MARK R & JAMIE L GOODALL
780 TAMARACK DR
CANYON LAKE, TX. 78133
TAMARACK SHORES MOBILE HOMES
SECTION II, LOT 179
COMAL COUNTY / 0.2459 ACRES

RE: 780 Tamarack Dr (permit #114806) - Supply and Flush Line Sleeving Variance Request

RE: 780 Tamarack Tamarack Shores II Lot 179

MARK R & JAMIE L GOODALL
 780 TAMARACK DR
 CANYON LAKE, TX. 78133
 TAMARACK SHORES MOBILE HOMES
 SECTION II, LOT 179
 COMAL COUNTY / 0.2459 ACRES

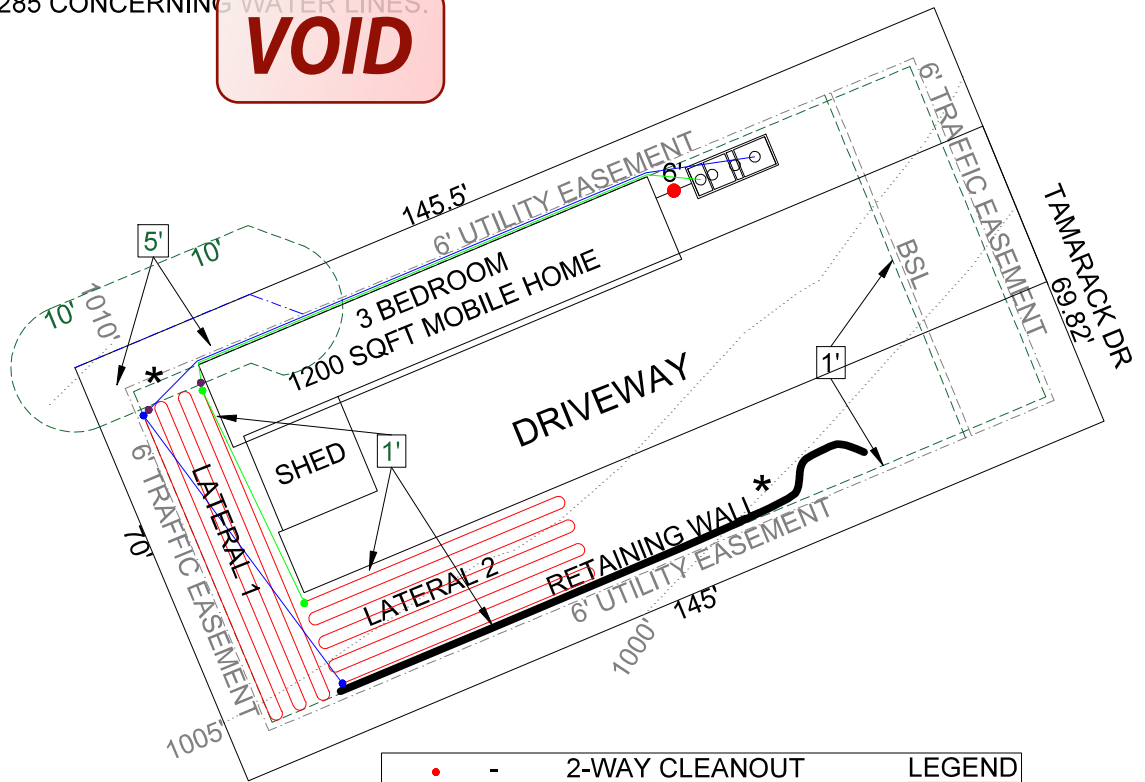
I am requesting a variance for the placement of supply and flush lines to be placed within 10' of a water line, and also where they cross the water line. This variance is requested due to limited space.

The supply and flush lines will be sleeved in SCH 40 PVC pipe where they are within 10' of the water line, and where they cross the water line in order to maintain equivalent protection.

MARK R & JAMIE L GOODALL
 780 TAMARACK DR
 CANYON LAKE, TX. 78133
 TAMARACK SHORES MOBILE HOMES
 SECTION II, LOT 179
 COMAL COUNTY / 0.2459 ACRES

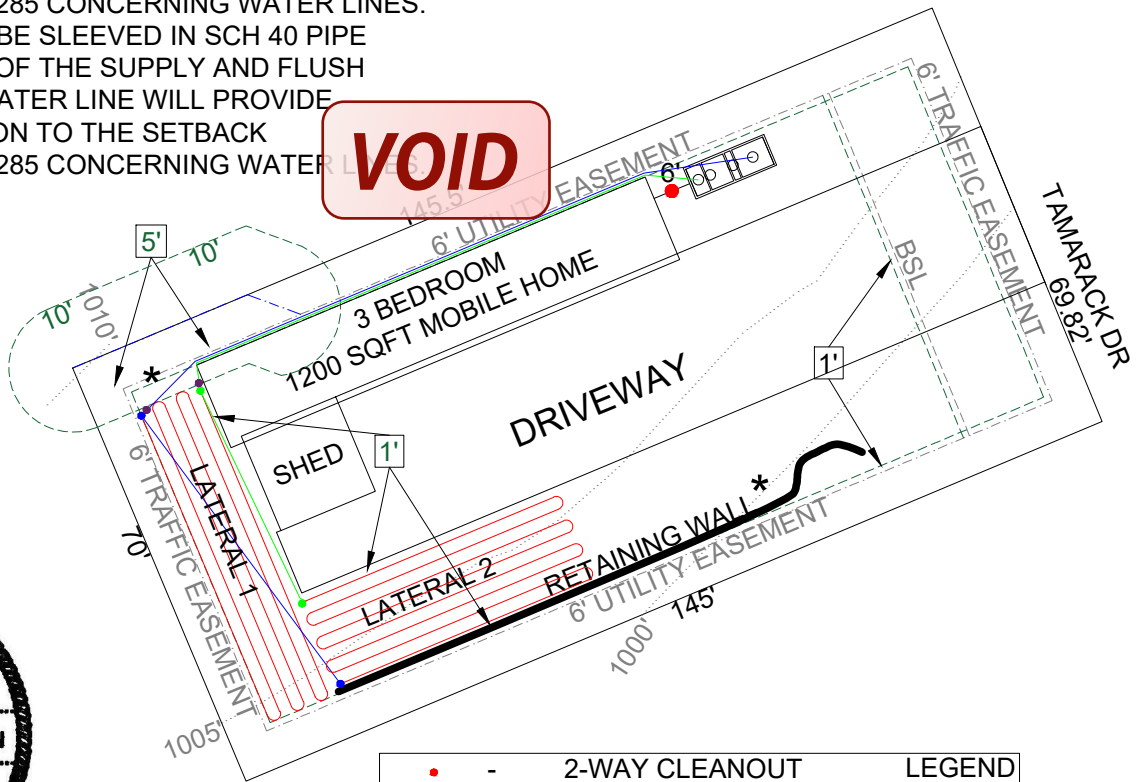
-  There is a 20ft separation distance from property line and edge of spray
2. Revise accordingly and resubmit.

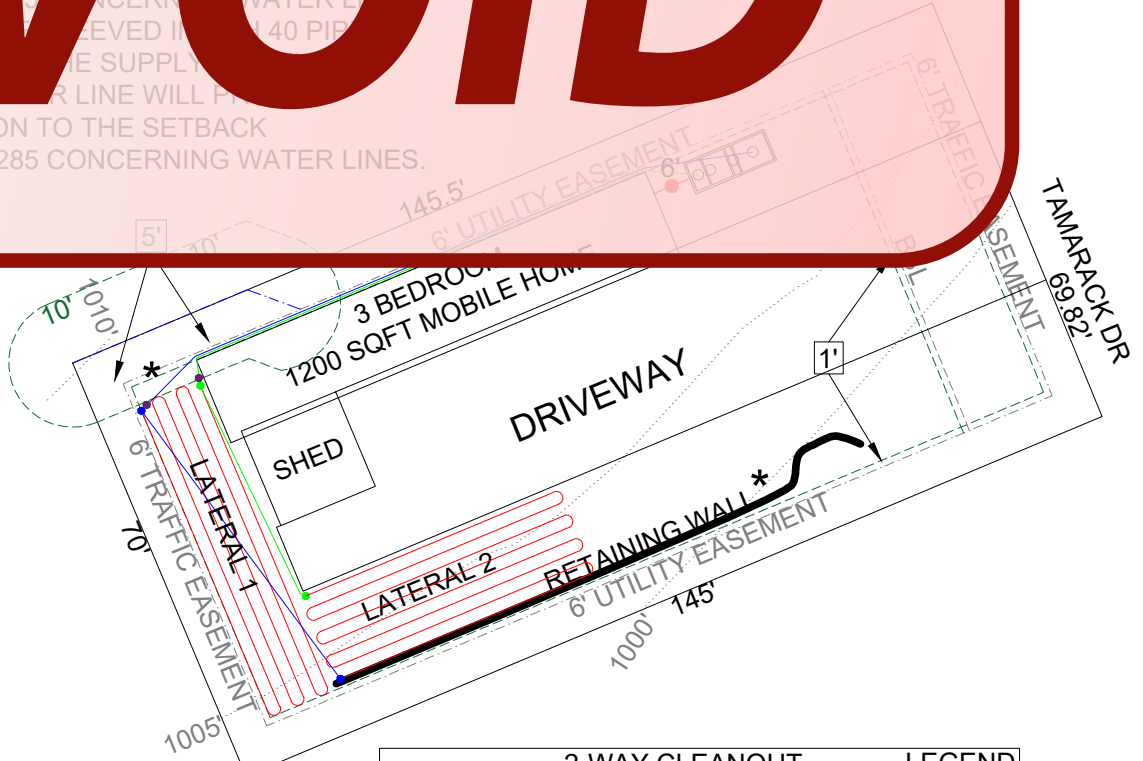
Landscaping Plan needs to be revised for the Drip System.

INSTALL 1" VACUUM BREAKER AT HIGHEST POINTS ON SUPPLY AND FLUSH WATER LINE WHERE IT CROSSES SUPPLY AND FLUSH LINES AND 10' BEYOND SLEEVING. WATER LINE WILL PROVIDE EQUIVALENT PROTECTION TO THE SETBACK REQUIREMENTS IN TAC 285 CONCERNING WATER LINES.

WATER LINE WILL BE SLEAVED IN 4" SCH 40 PIPE WHERE IT IS WITHIN 10' OF THE SUPPLY LINES. SLEEVING THE WATER LINE WILL PROVIDE EQUIVALENT PROTECTION TO THE SETBACK REQUIREMENTS IN TAC 285 CONCERNING WATER LINES.
